A partir del 19 de Julio de 2018, entra en vigor el suplemento 13 de la serie 04 del Reglamento 44.04, en el cual se realizan entre otras modificaciones, la modificación del punto 6.2.2 para clarificar los requisitos que debe cumplir la ruta del cinturón de la parte abdominal.

Con este documento se puede identificar claramente que el sistema de retención SmartKidbelt, no cumple con los requisitos del Reglamento 44.04 de Sistemas de Retención Infantil.

Figures of Strapped child

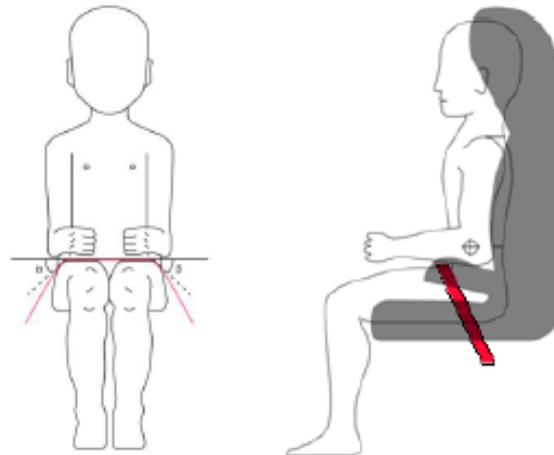
Paragraph 6.2.2., amend to read:

"6.2.2. All restraint devices utilizing a "lap strap" shall positively guide the "lap strap" on both sides to ensure that the loads transmitted by the "lap strap" are transmitted through the pelvis. The assembly shall not subject weak parts of the child's body (abdomen, crotch, etc.) to excessive stresses.

In the case of booster cushions and booster seats, the lap portion of the adult seat belt shall be positively guided on both sides to ensure that the loads are transmitted by the adult lap belt are transmitted through the pelvis. The positive guidance of loads over the pelvis shall be realised from the moment that the child is installed; the lap belt shall pass over the top of the thigh, just touching the fold with the pelvis. The angles α and β between the tangent line in which the belt touches the thighs and the horizontal shall be greater than 10° .
